ADDENDUM
NO. 1

August 28, 2020

New Buffalo Twp. Public Safety Building
18959 Highway US 12
New Buffalo, MI 49117

ADDENDUM NO. 1

CONCRETE APRON DETAIL

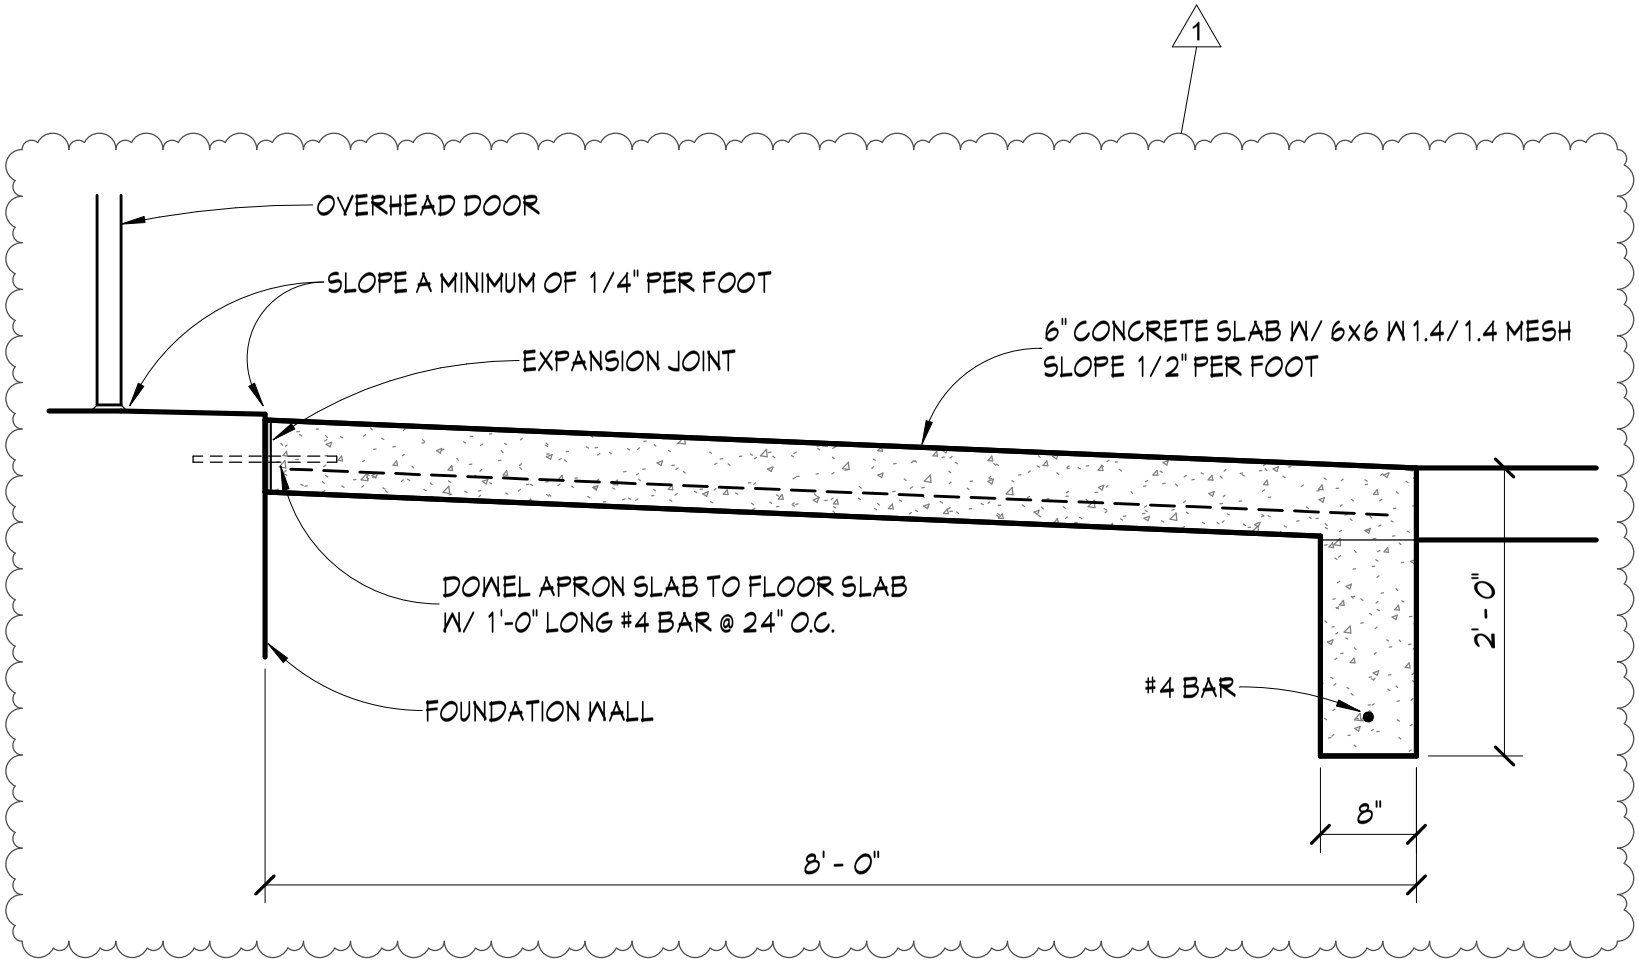
10. Concrete stoops – Other than the sidewalks leading to Doors 1, 24 & 25, them there is an 11’ x 12’ stoop/pad at Doors 50 & 51 and an 8’ deep stop/pad in front of Doors 26-31 and 44-47. The area in front of Doors 40-42 is part of the concrete drive in that area. These stoops to be 6” thick with a 24” turn down edge per the attached 2-Concrete Apron Detail. The stoops and sidewalks are to be doweled to the building foundation per the note on Sheet A-2.

NOTE:
THIS DETAIL IS TYPICAL FOR ALL CONCRETE APRONS IN FRONT OF OVERHEAD DOORS

Storefront and Flanged Window Head

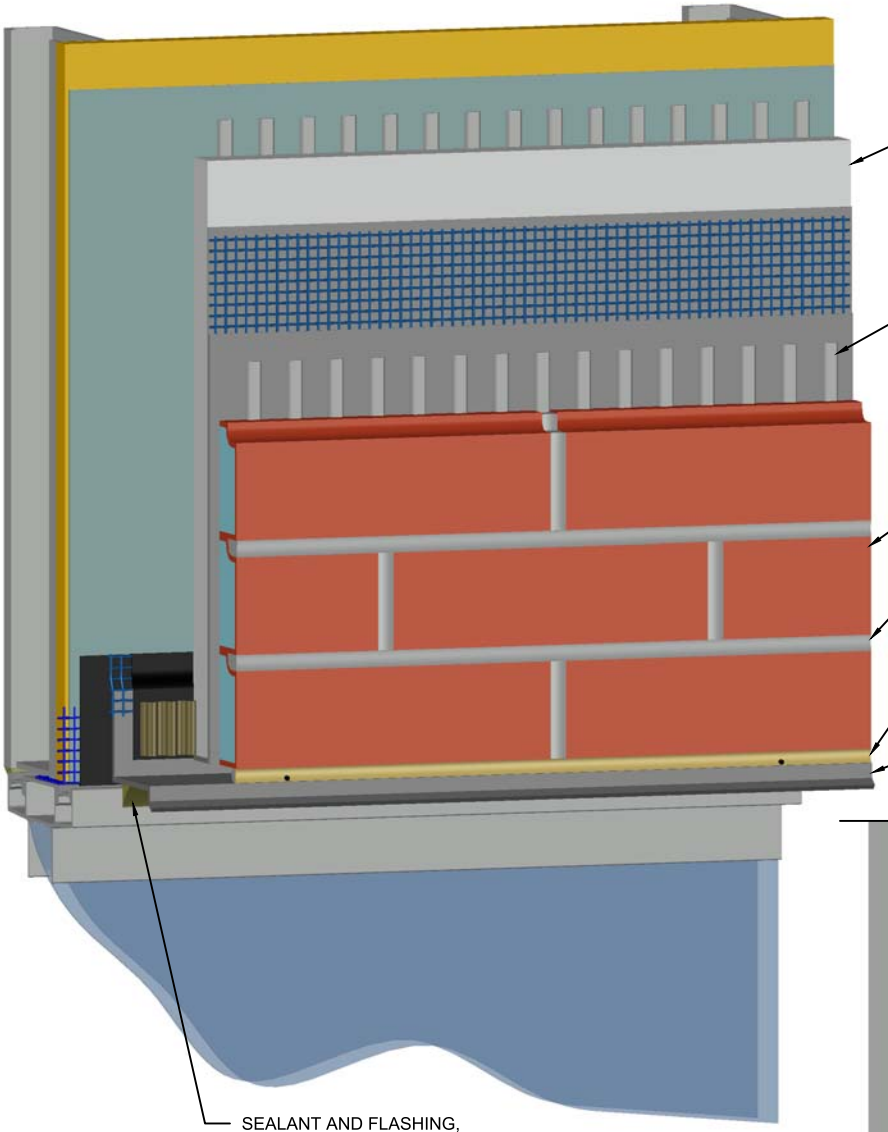
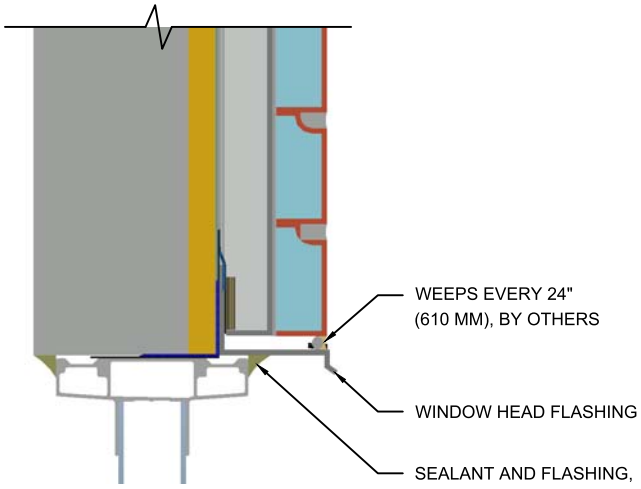
9. New Brick – Color to be Riverbank -900BST with iron cut texture and no effects. Details for the head, jamb and sills on the window shall be per the attached detail “New Brick sill and jamb” and “New Brick head detail”
